Ashton Village Center

SECTOR PLAN

Ashton Village Center Sector Plan

Work Session #2

Roadways

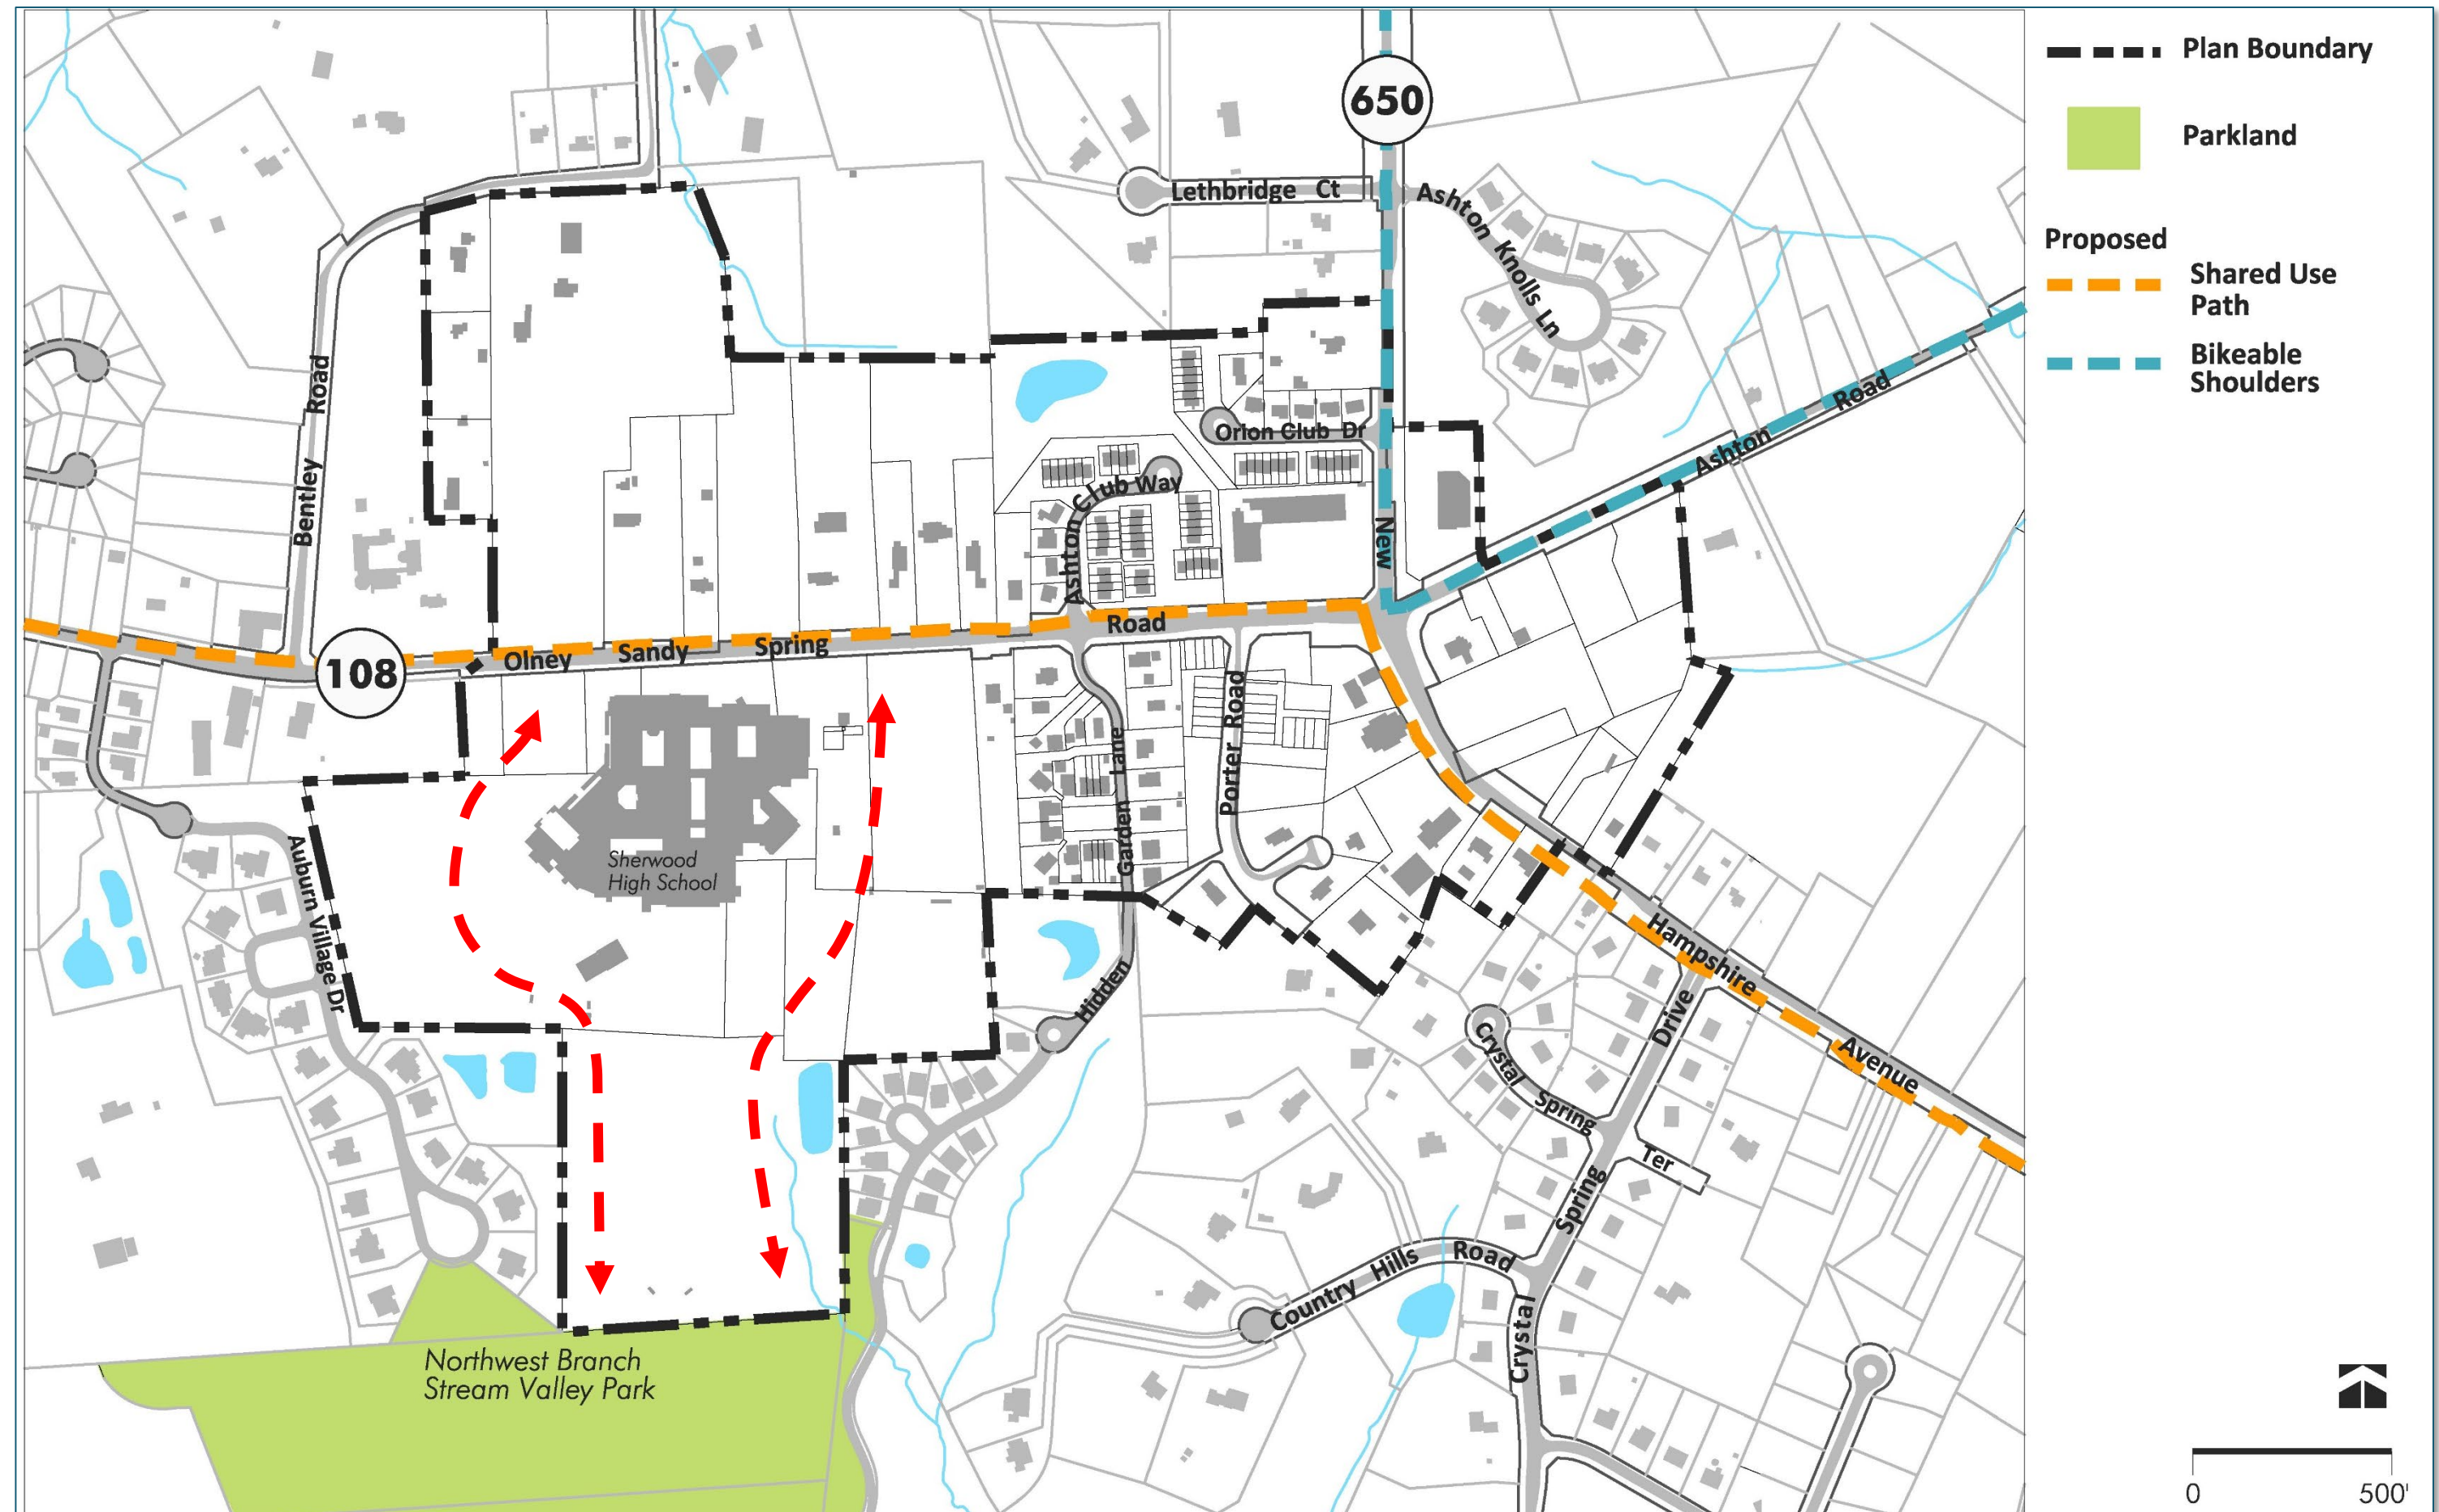
- Concerns about traffic in Ashton (three rush hours)
- Long wait times at MD 108/650 intersection
- New development will worsen traffic

- Retain the Plan's recommendation to maintain the current pavement width except for improvements that increase safety

Bikeways and Pedestrian Network

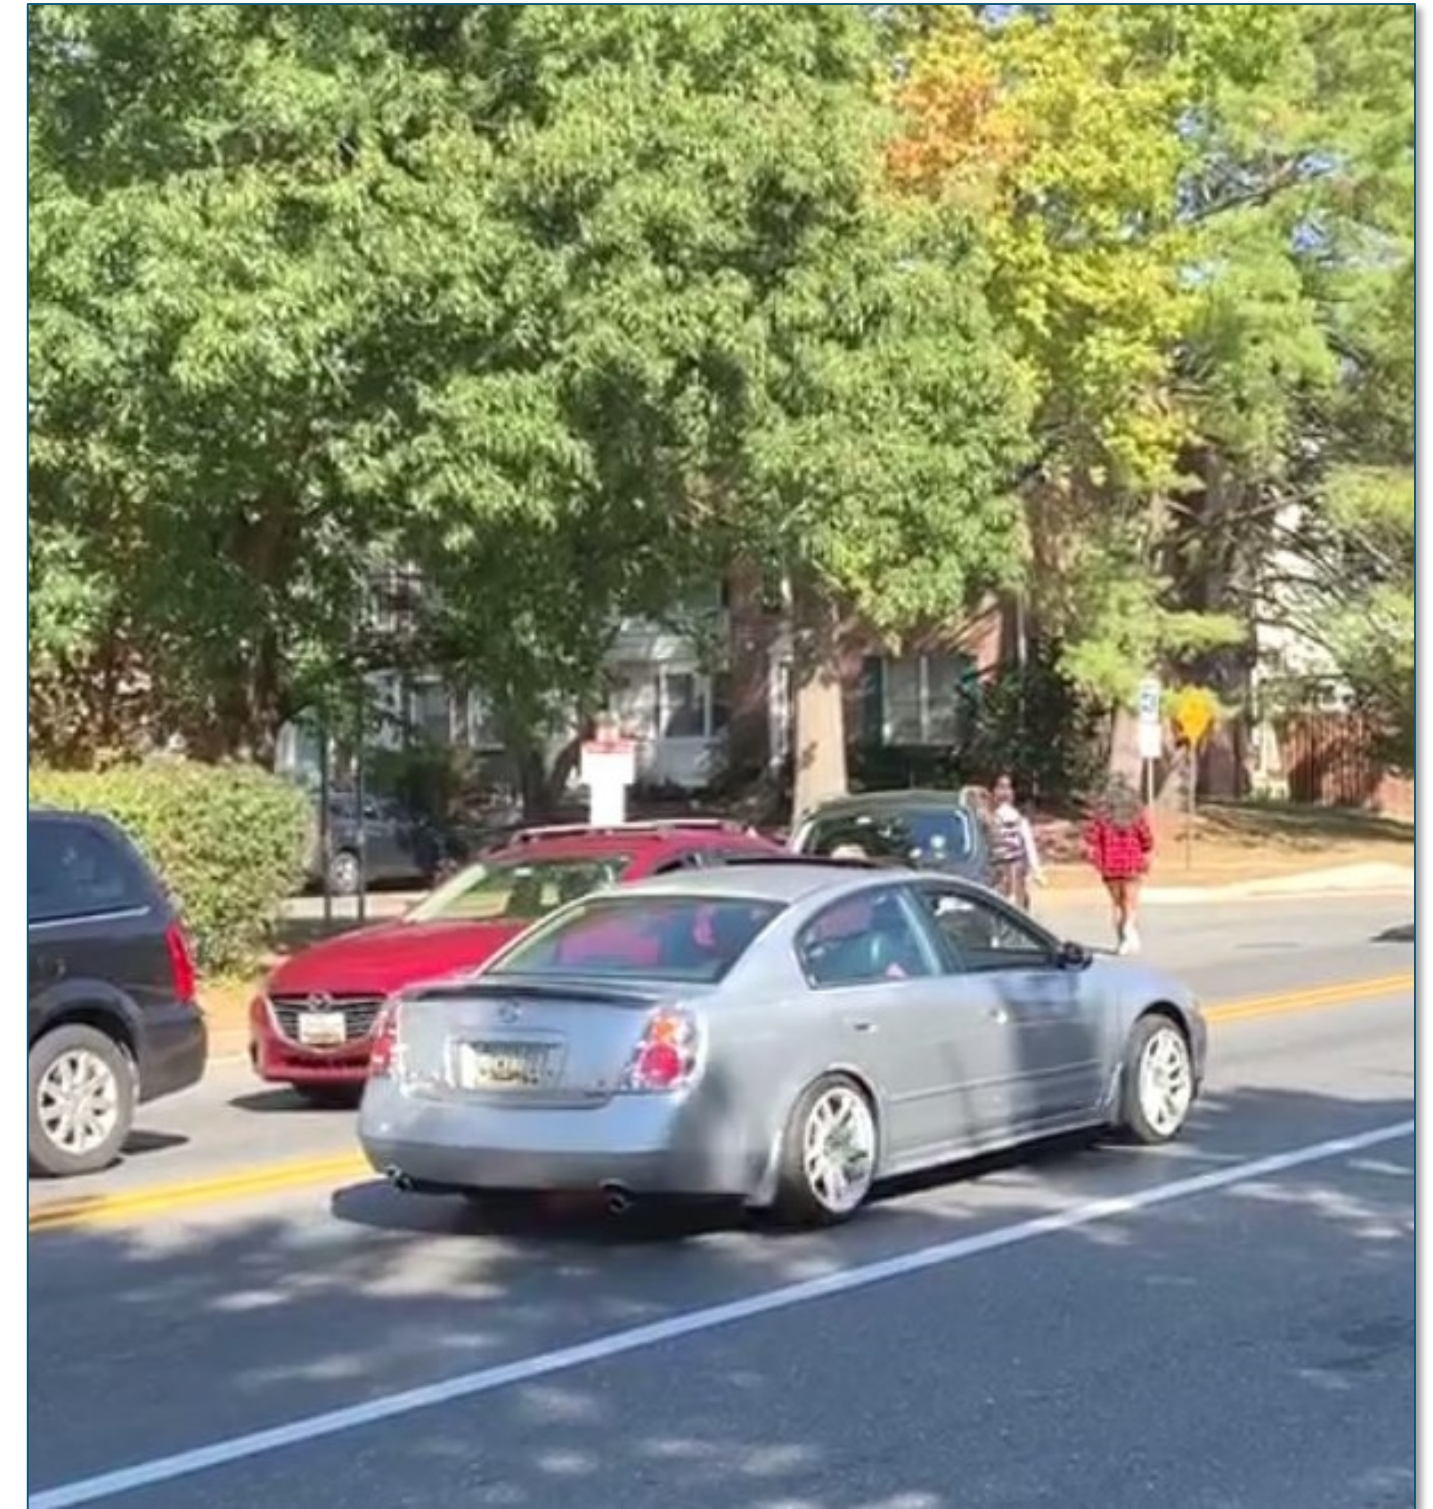
- Widely supported
- Lack of funding
- Skepticism that students would use crosswalk

- Retain the Plan's recommendations for bicycle and pedestrian improvements

Southeast Quadrant

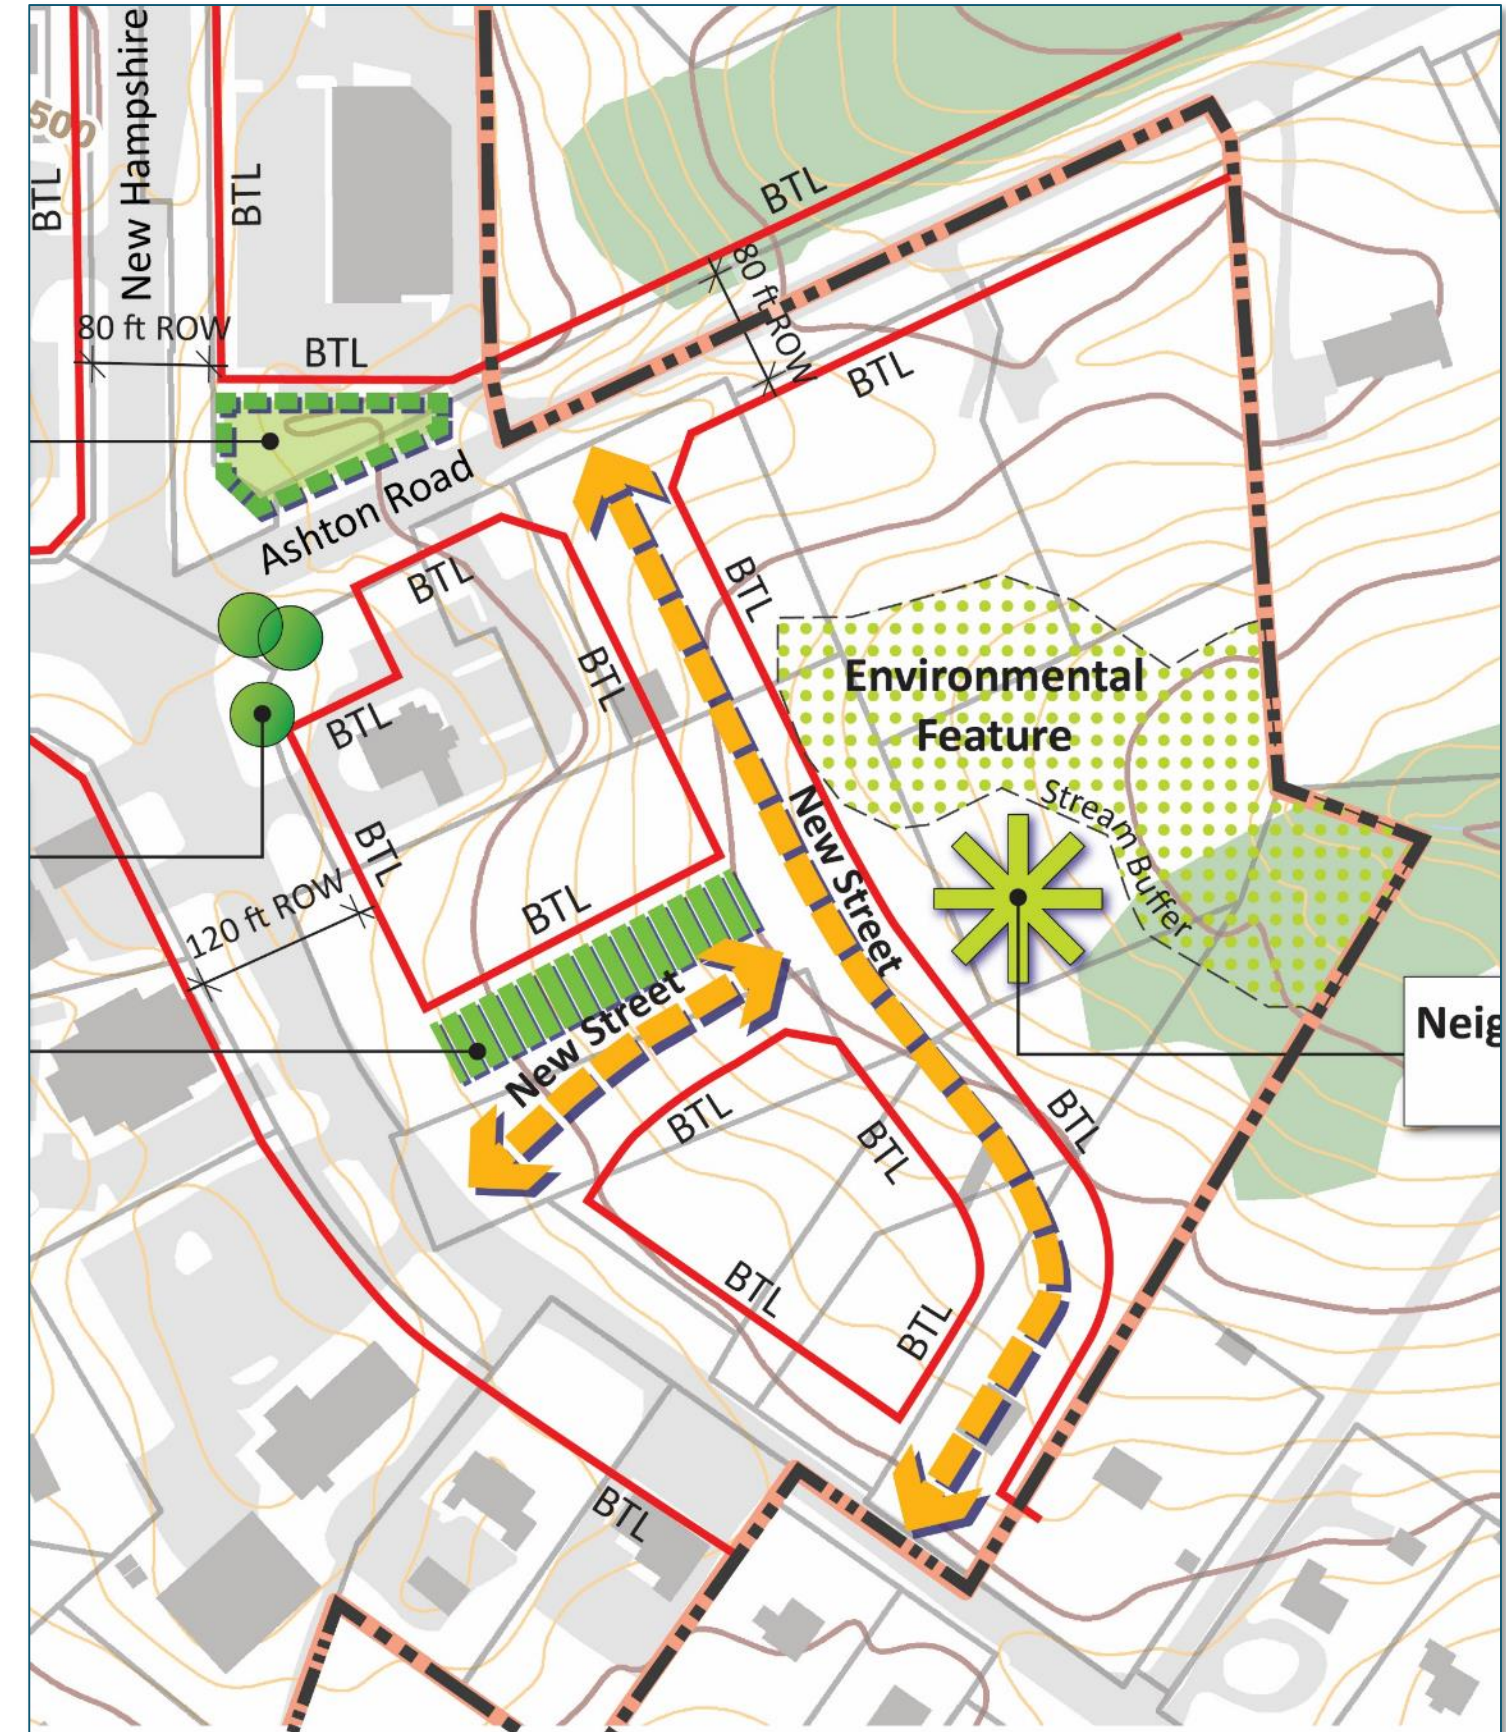
- Concerns with more intersections along MD 108 and MD 650
- Change “shall” to “should” regarding designing circulation to discourage cut-through traffic

- Retain the Plan’s recommendations
